CONSTRUCTION DRAWINGS FOX RUN NATURE CENTER

EPC STORMWATER REVIEW COMMENTS
IN ORANGE BOXES WITH BLACK TEXT

SHEET INDEX	
SHEET NUMBER	SHEET TITLE
C1	COVER
C2	EXISTING CONDITIONS & DEMO PLAN I
C3	EXISTING CONDITIONS & DEMO PLAN II
C4	SITE PLAN
C5	SIGNING & STRIPING PLAN
C6	DRIVEWAY & PARKING AREA GRADING PLAN
C7	BUILDING GRADING PLAN
C8	ROAD RECLAMATION GRADING PLAN
C9	WALL PLAN AND PROFILE I
C10	WALL PLAN AND PROFILE II
C11	WALL PLAN AND PROFILE III
C12	WALL PLAN AND PROFILE IV
C13	UTILITY SERVICES PLAN
C14	OFF-SITE WATER SYSTEM PLAN
C15	ON-SITE WATER SYSTEM PLAN
C16	OVERALL STORM SYSTEM PLAN
C17	ROOF DRAIN AND PATIO PLAN AND PROFILE
C18	POND PLAN AND PROFILE
C19	DETAILS

EL PASO COUNTY PARKS
FOX RUN NATURE CENTER
ROAD RECLAMATION GRADING PLAN
EL PASO COUNTY

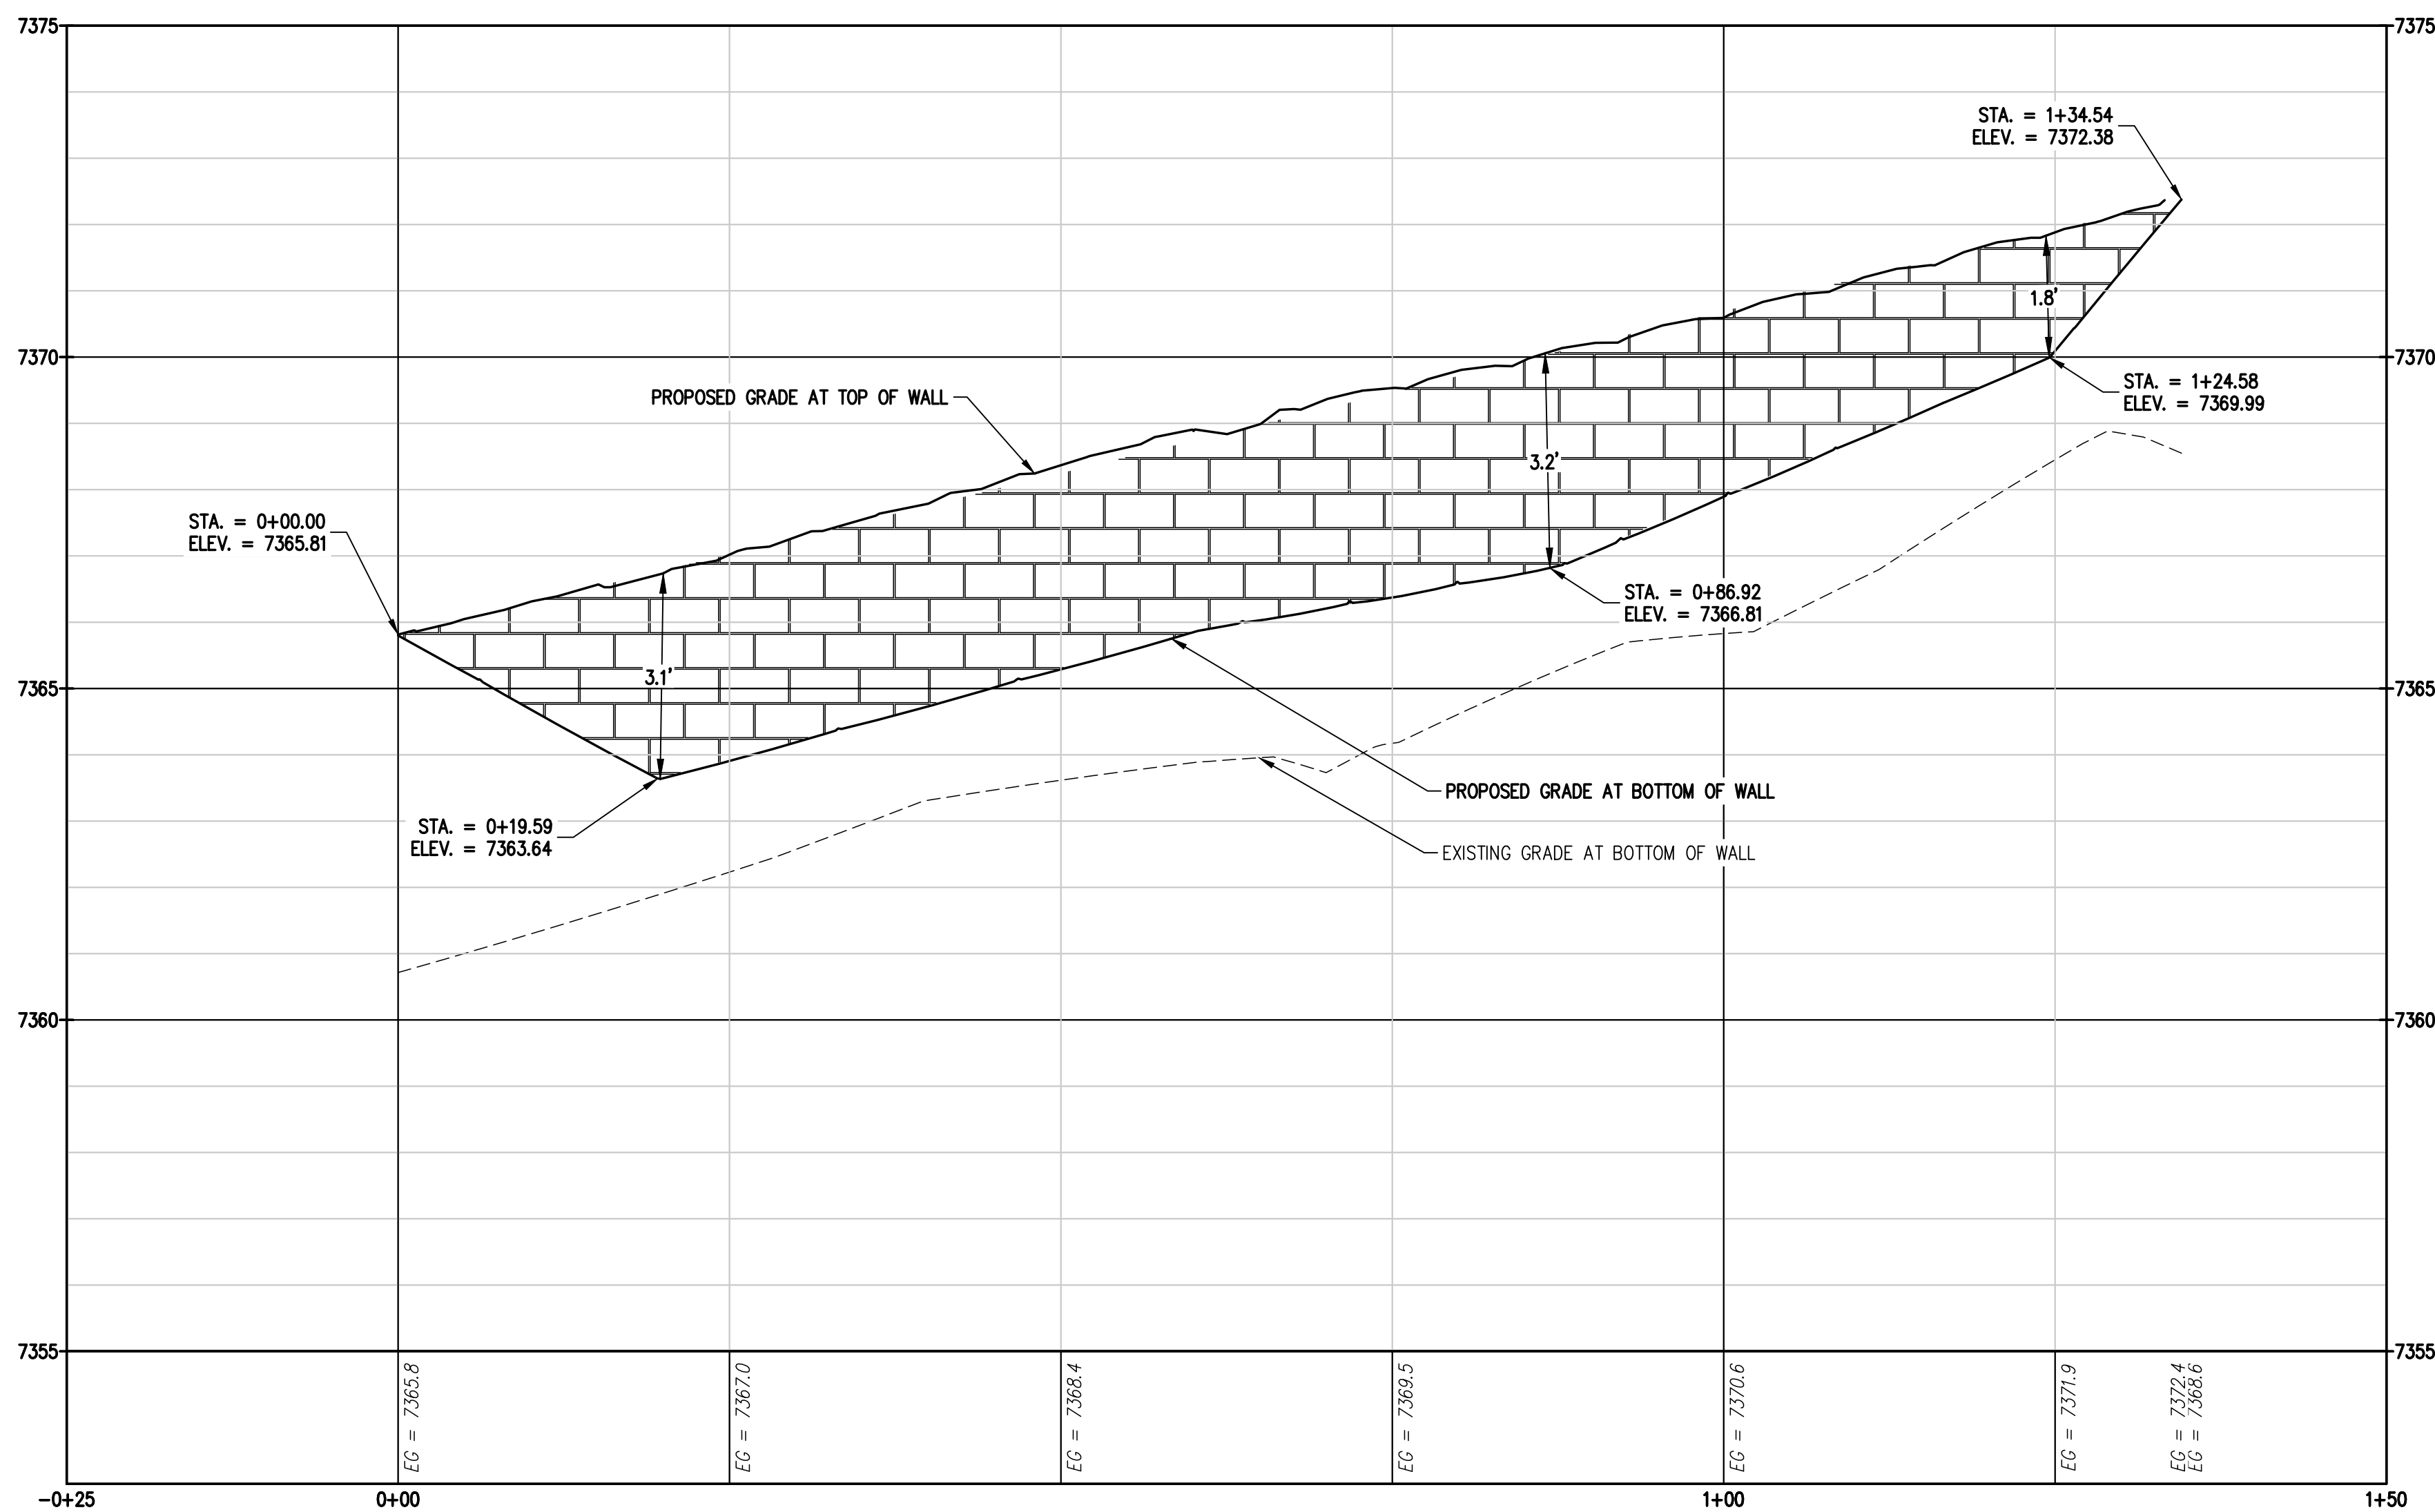
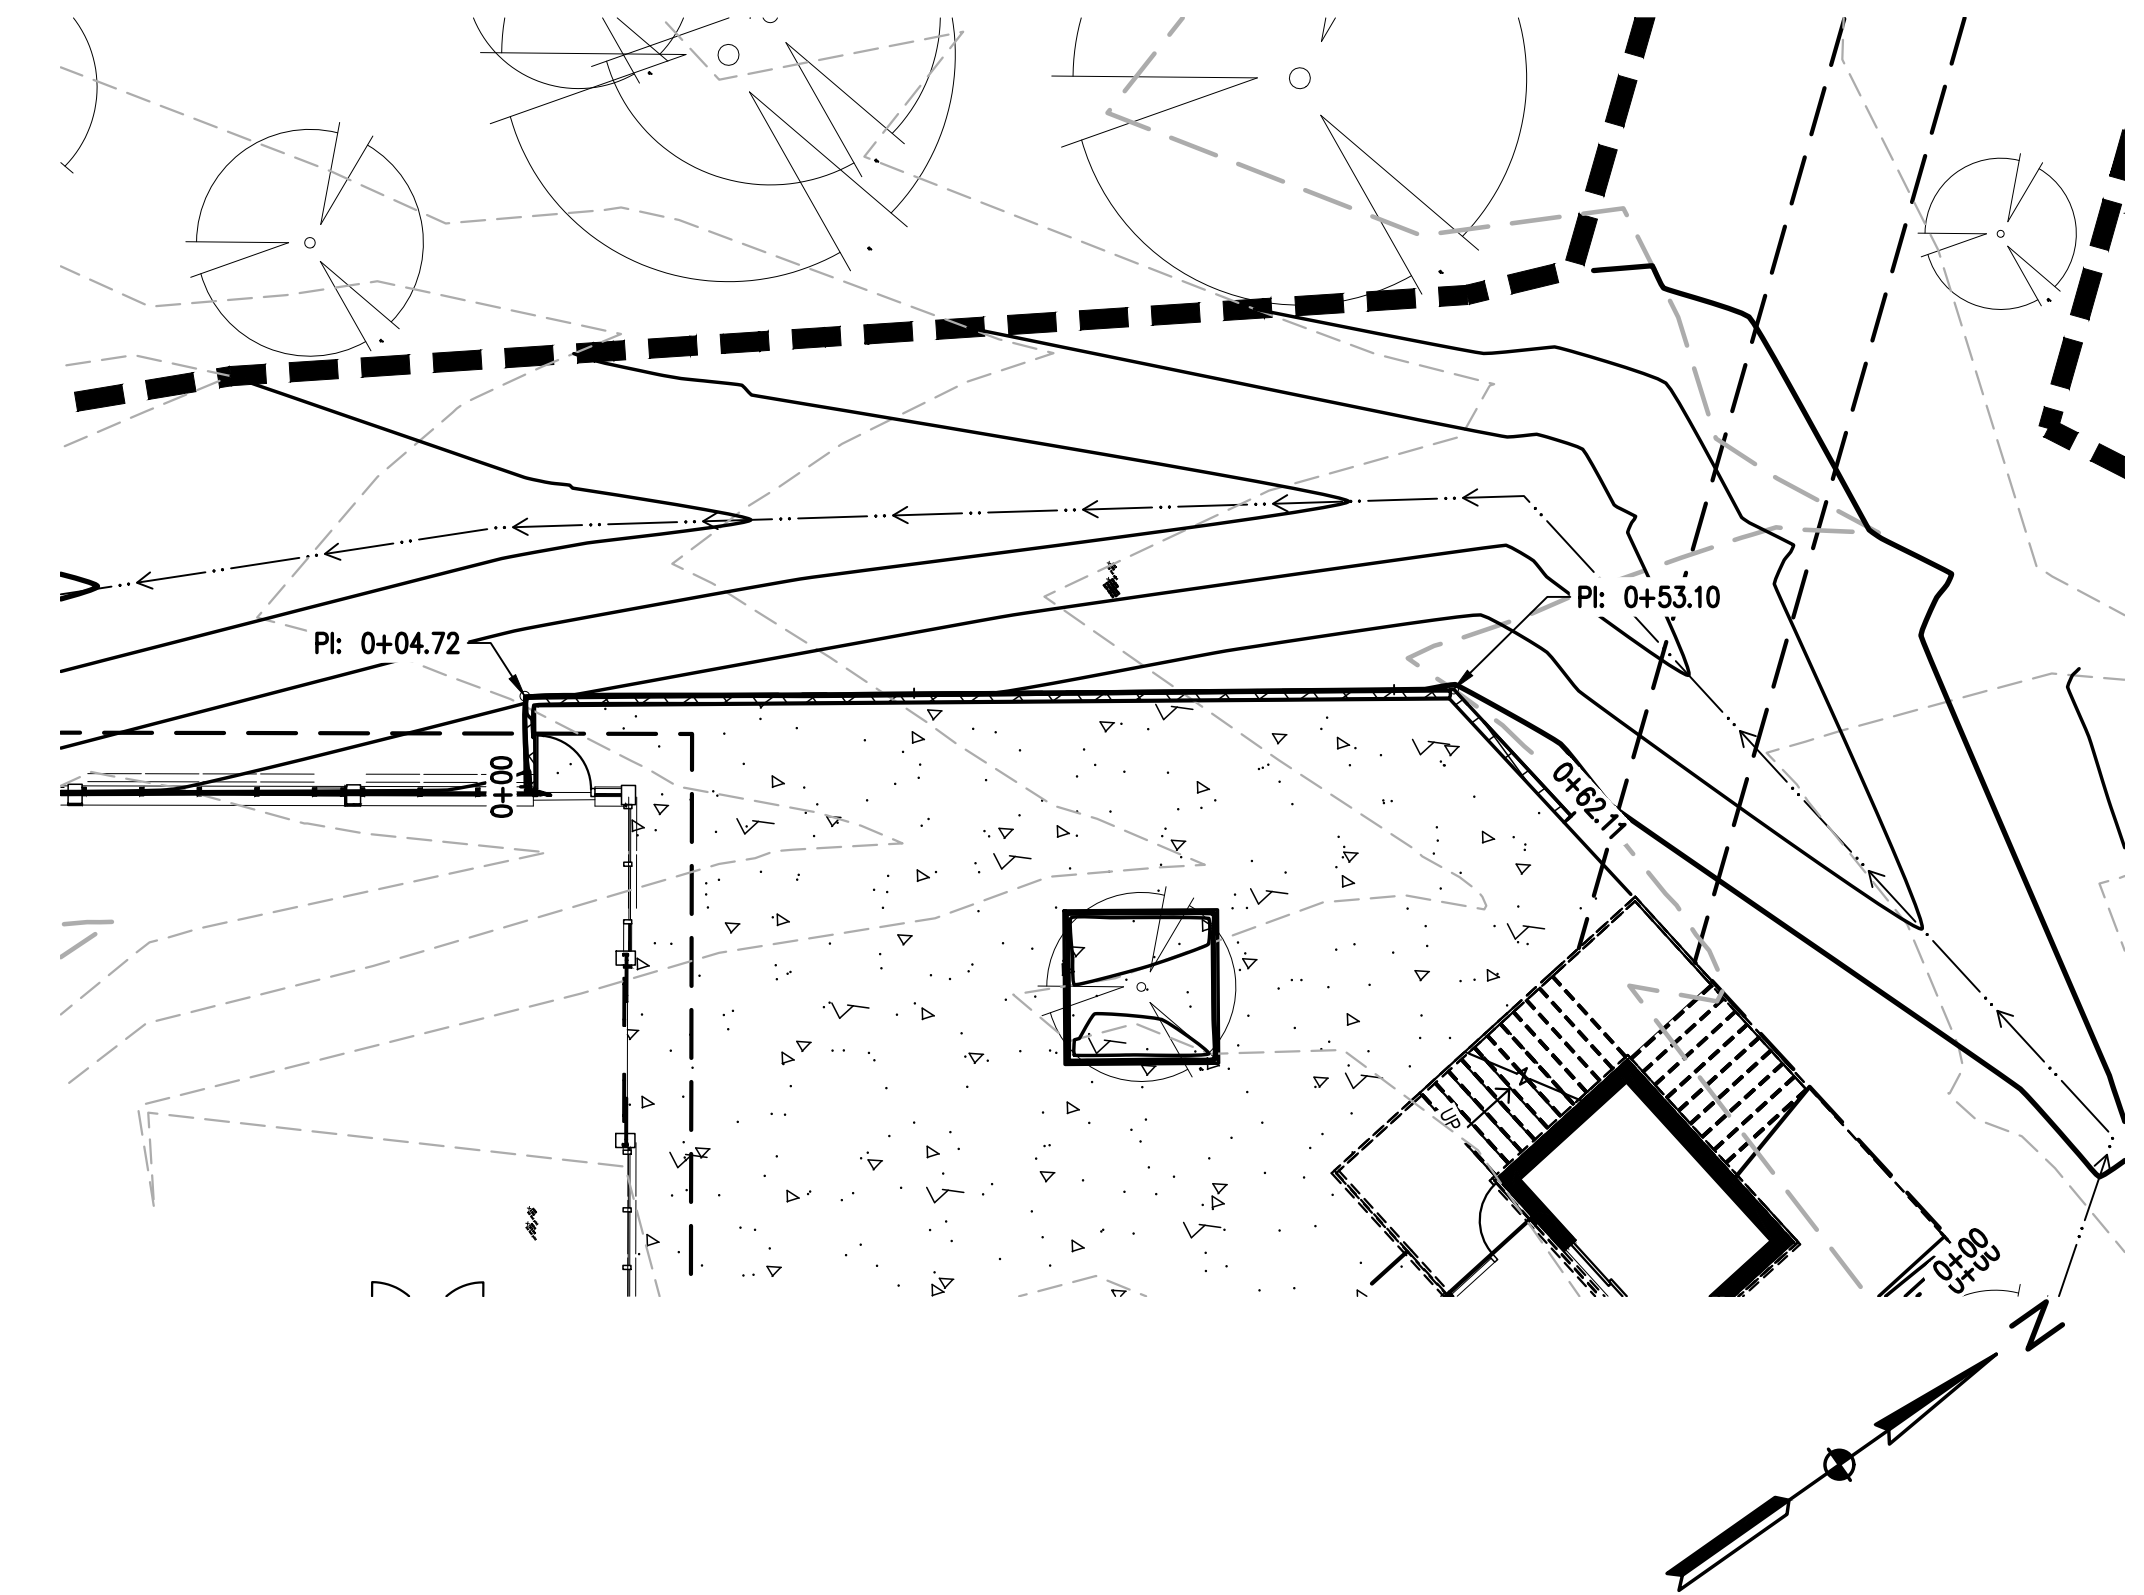
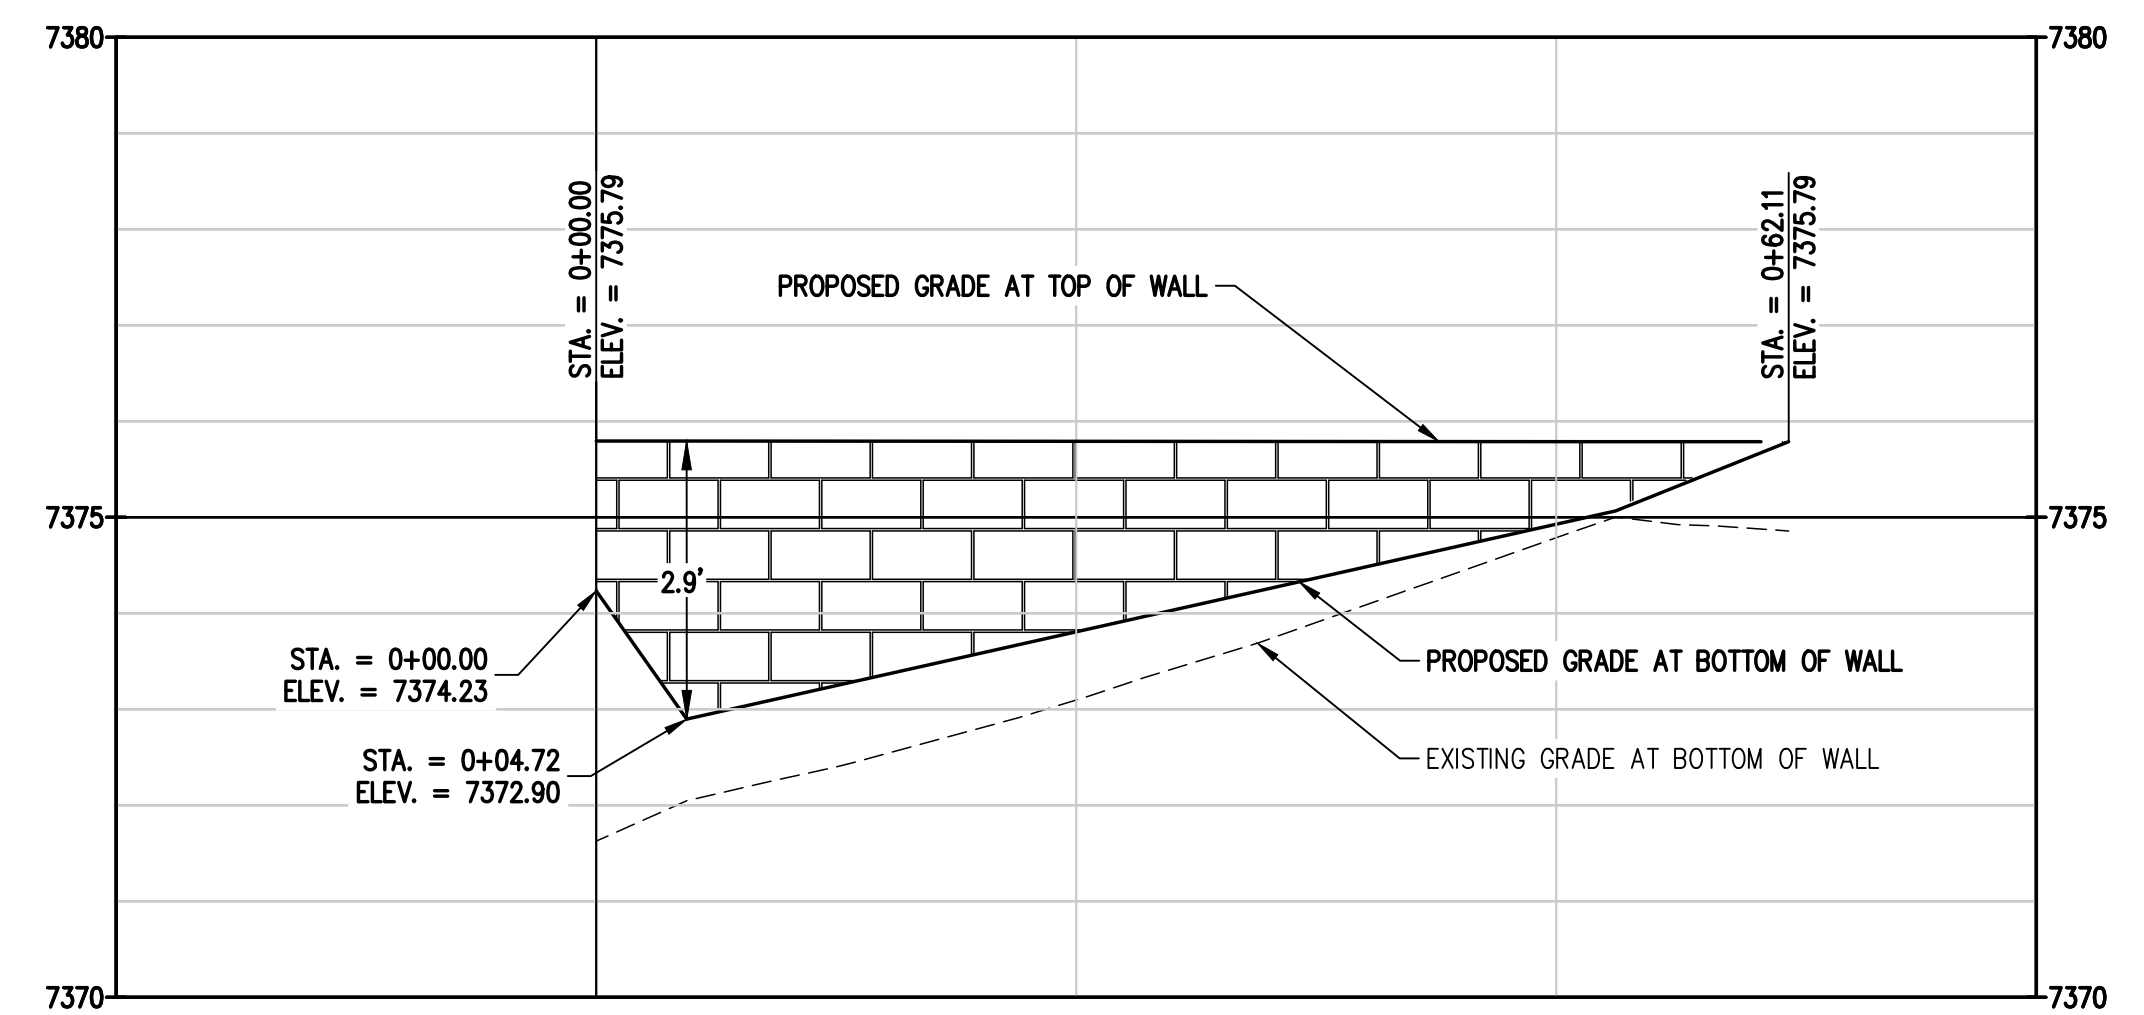
Ensure that proposed contours tie back into exiting
